Re: TransCanada Project Nos. 1892-026, 1855-045 and 1904-073

TransCanada Hydro Northeast Inc. Consolidated Report
Study 2/3 Riverbank Transect and Riverbank Erosion Study

Contents: Landowner's Comments and Recommendations Consolidated Studies 2/3

Figure 1. Collapse of a portion of Wilder impoundment bank in spring of 2011 necessitating reconstruction of 1200 feet of River Road near its intersection with the North Thetford Road in Lyme , New Hampshire.

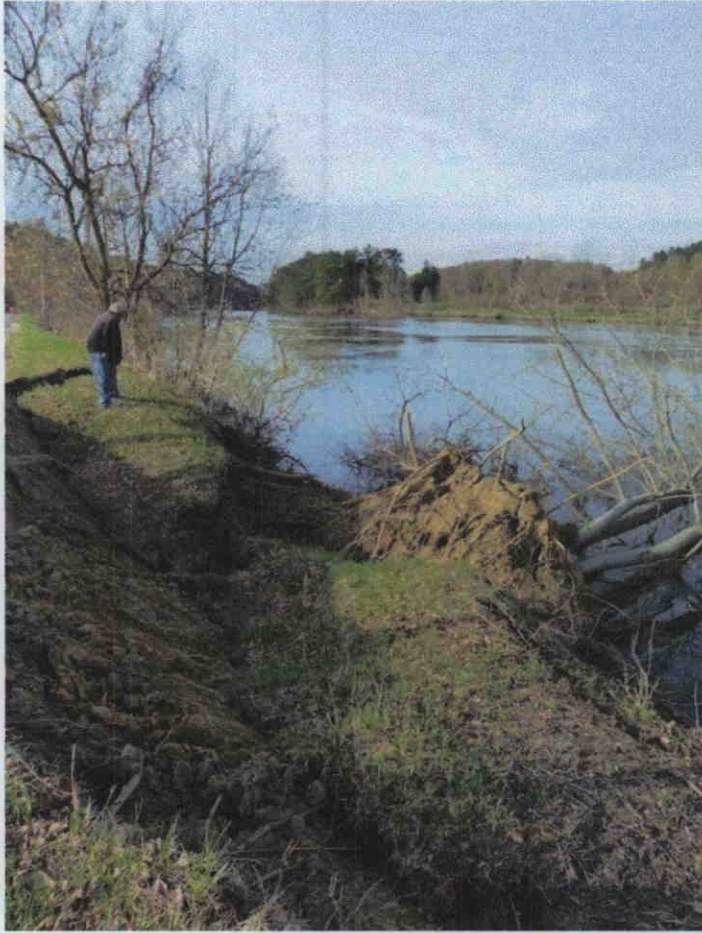
Lyme's consulting engineer on the repair of this damage, HTE Northeast, Inc. stated that the cause of the bank collapse was long-term erosion and undermining due to flow action, and existence of water in the riverbank soils. **"The frequent raising and lowering of the water level by downstream dam management (Wilder Dam), over time, is a contributing factor."**

Fig. 3 I have annotated figure 20 in Appendix A of study 2 and 3 (Also described as Appendix D, Plate 3 of 14) to show this section of River Road. It is classified for erosion

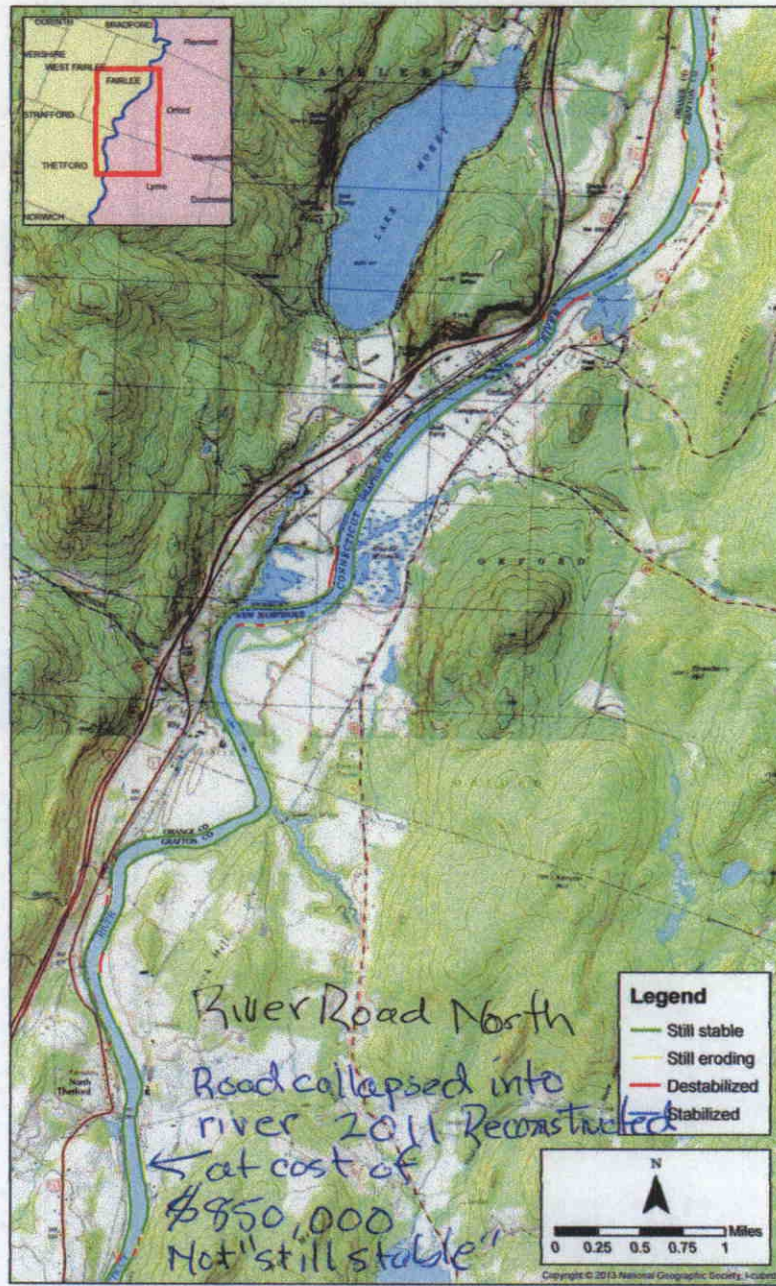
as “still stable” in 2014. There is no mention that this section of road and the river bank has been completely reconstructed.

Fig4. This is the “dog leg” of the reconstructed road. It can be viewed from the river as well. Why was this change not noted on 2014 map of survey of erosion?

Note: At the August 25 meeting at which the results of the combined Study 2 and 3 were presented by TransCanada and at which I objected to the results presented in the two figures cited above, John Ragonese of TransCanada stated that he would have a look at the figures I described in the report Appendix and that they "would be changed." FERC should make certain that they are changed.

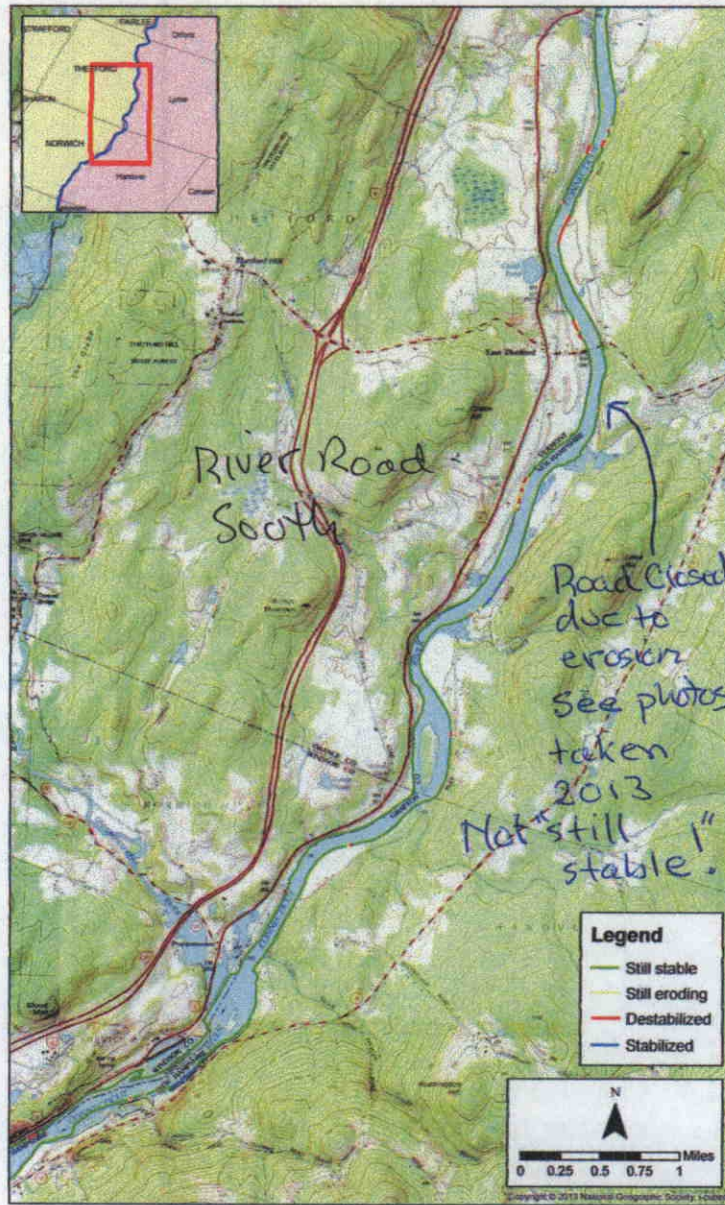
Fig. 7 Annotated Figure 21 from Appendix A (Also described as Appendix D plate 4 of 14) showing River Road south of the bridge to East Thetford, VT. Note that this section is classified as “still stable” despite a large hole in the bank adjacent to road and subsiding pavement road pavement above. The hole is easily visible from river, but the sagging road surface is not easily seen from river.

From the methodology described in the study report, I understand that update of the GIS georeference files employed aerial photographs from 2010. The figures above are labeled "Comparison of 1958 and 2014 erosion. I do not find aerial photos from 2014 mentioned. Where was the data for the period, 2010 to 2014 obtained? From the field mapping of bank conditions described in section 5.6 of the report? From LIDAR? I was with Mr. Field when he visited both sections of river road described above, and climbed down and around the hole under the section recently closed to traffic. How did this section of the bank get classified incorrectly?

Figure 2. Sequence of stage fluctuation with attendant recharge into pervious zones (sections b, d, and e) and subsequent piping/sapping and failure (sections c, f, and g)

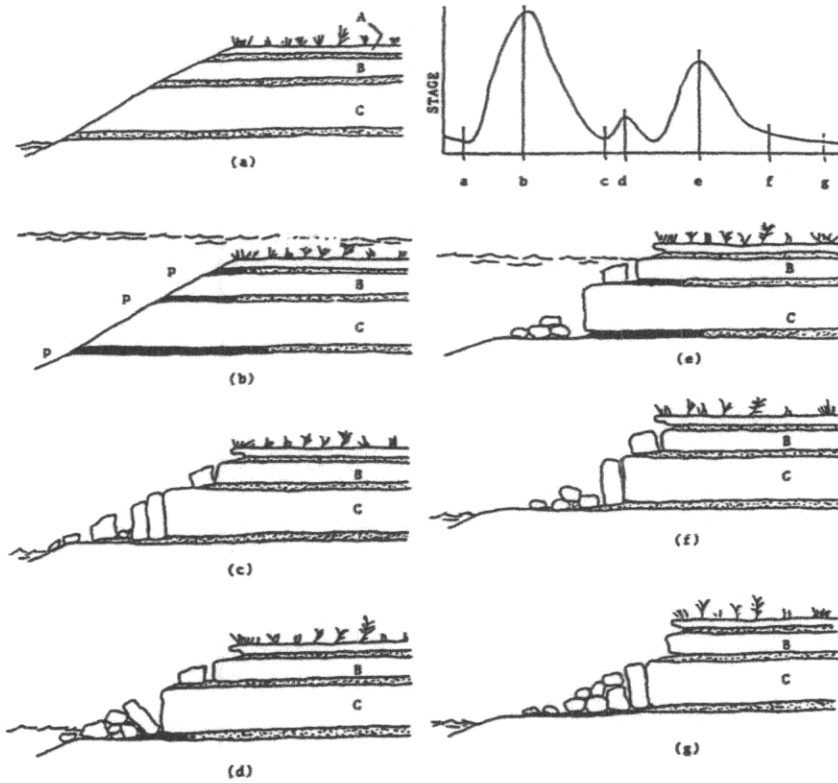
The lesson that was offered, however, ignored or failed to give adequate emphasis to an important cause of the type of erosion most likely to be active as a result of dam operations. This is piping, or as referred to by the applicant in the report “seepage” erosion.’

The failure of the report of studies 2 and 3 to include a diagram like the one shown in Figure of this report, as part of the tutorial on erosion is a deplorable omission.

Fig 9 of my comments is taken from Identification of Piping and Sapping Erosion of Streambanks, by D.J. Hagerty, Prepared for the Department of the Army, U.S. Army Corps of Engineers. Contract Report HL-92-1 Water infiltration into susceptible soils when they are exposed to elevated water levels results in loss of material when water
